# UNITED STATES PATENT AND TRADEMARK OFFICE

APPLICATION NO.	FILING DATE	FIRST NAMED INVENTOR	ATTORNEY DOCKET NO.	CONFIRMATION NO.
10/733,512	12/11/2003	Carsten Ziegs	H&U119	9222
41022	7590	07/17/2006	EXAMINER FLORES SANCHEZ, OMAR	
MARLANA TITUS 6005 RIGGS ROAD LAYTONSVILLE, MD 20882			ART UNIT 3724	PAPER NUMBER

# Office Action Summary

### DETAILED ACTION

Fig. 1

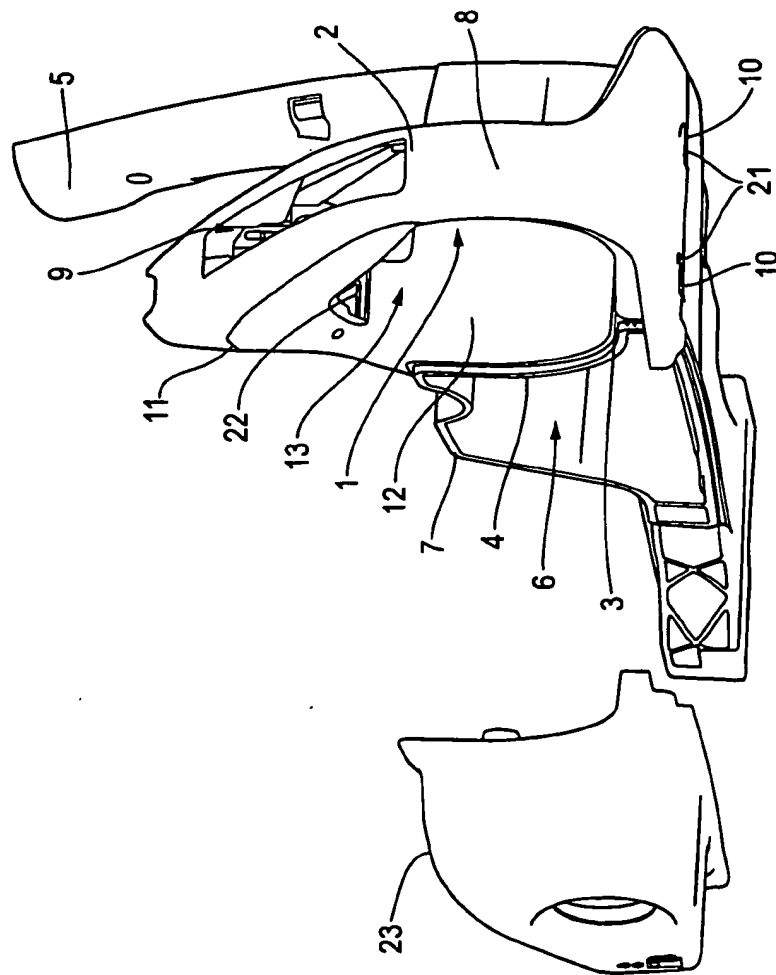
Green teaches portion 20a which is capable of receiving the foot of the user for support. Also, applicant's handle shell 8 is not covering the foot portion 3, which is located on top of the lower portion 19 of the handle shell.
